Docket Item # 3
BAR CASE # 2009-0074

ISSUE: Alterations
APPLICANT: Mitchell Bober
LOCATION: 325 South Lee Street
ZONE: RM Residential

The applicant is requesting approval of a Certificate of Appropriateness for alterations at 325 South Lee Street. The applicant is proposing the replacement of an existing garden gate and the construction of a new flat brick arch above the gate which will be mounted to the existing garden wall. The existing wooden gate that the applicant has requested to replace is in a state of disrepair. The applicant is proposing the installation of a new wrought iron garden gate with minimal decorative detail. The proposed masonry arch will be constructed of seven brick courses above the existing brick garden wall where the third course of brick will be constructed as a belt course. The applicant has indicated that he intends to use brick and mortar to match the existing brick wall in construction of the new arch.

Figure 2. Proposed garden gate and masonry arch.

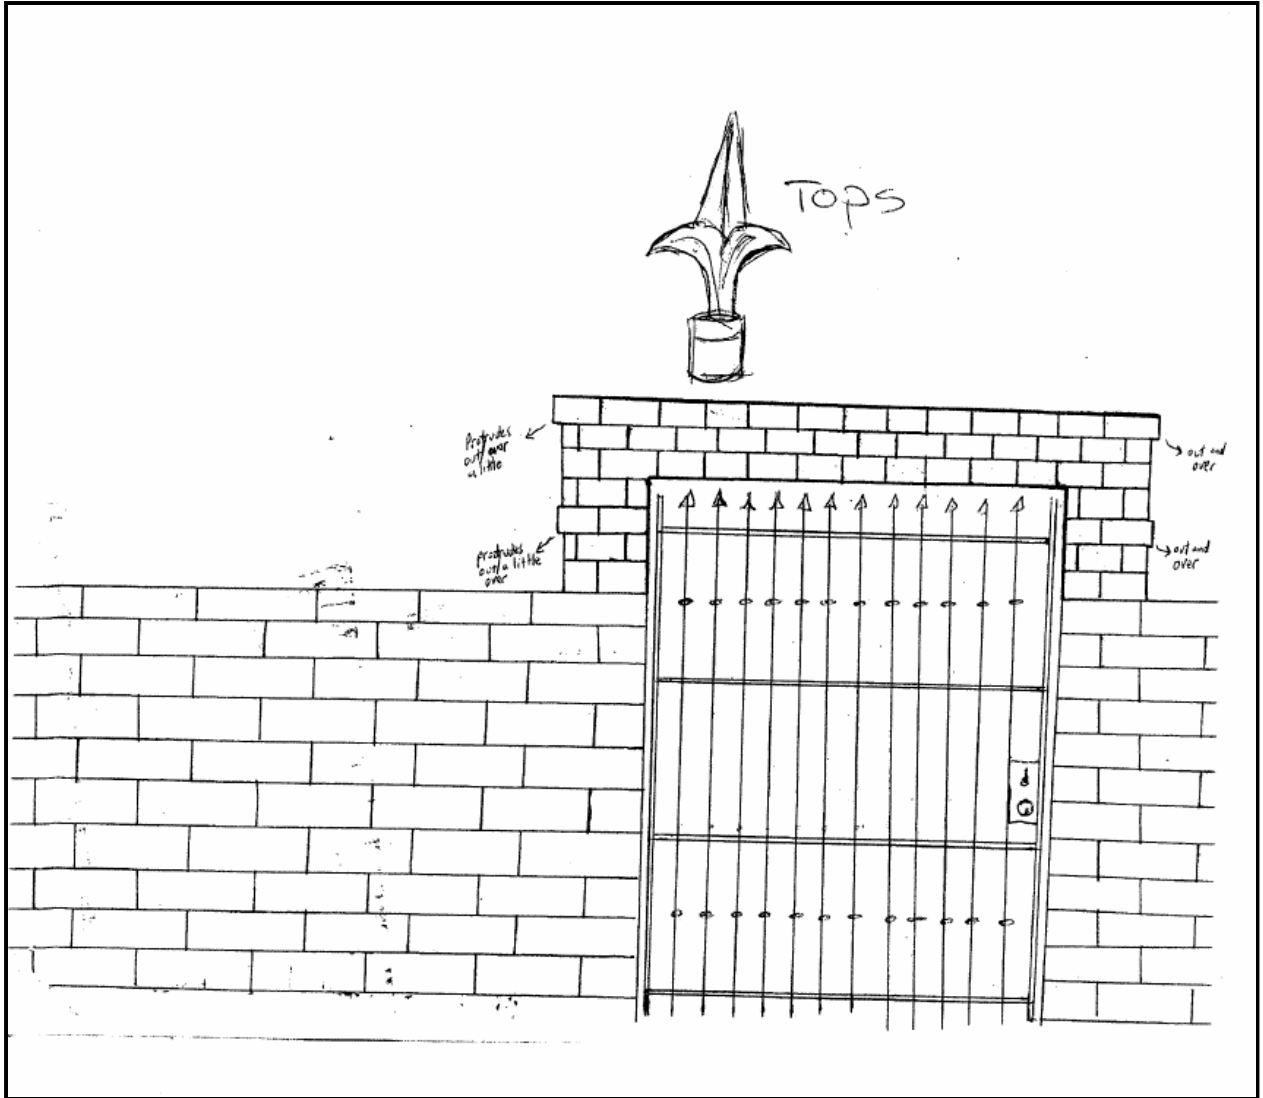
According to the *Design Guidelines*, "Fences, garden walls and gates should be appropriate in materials, design and scale to the period and character of the structure they surround" In Staff's opinion, the proposed wrought iron gate and brick arch are in keeping with both the period and style of the home. Additionally, as stated in the *Design Guidelines*, "A number of different types of materials are appropriate for fences, garden walls and gates throughout the historic district," therefore Staff has no objection to the applicant replacing the existing wooden gate with a wrought iron gate. Staff finds the proposed wrought iron gate to be an improvement both visually and spatially as it will increase the transparency of the streetscape and open the view into the garden. The garden gate as depicted the attached drawing submitted by the applicant, as well as a photograph of a similar gate at 210 Duke Street, is one that is both aesthetically and structurally well designed. The finials give an otherwise heavy duty or utilitarian gate a residential appeal.

It is Staff's opinion that the construction of a brick archway over the existing entryway to be a compatible addition to the garden wall. The applicant has indicated that the archway will be constructed using the same brick as used in recent construction in the rear yard of the property that was purchased to match the existing garden wall, therefore, Staff finds the alteration to be appropriate to the house and the historic district. In 2007, the Board approved similar construction of a new archway to an existing brick wall located at 502 Duke Street. (BAR 2007-0073). The brick archway constructed at 502 Duke Street is rounded, however, a list compiled and submitted by the applicant shows the prevalence in the Old and Historic District of square arches in the same style as the one proposed.

Staff recommends approval of the application as submitted.
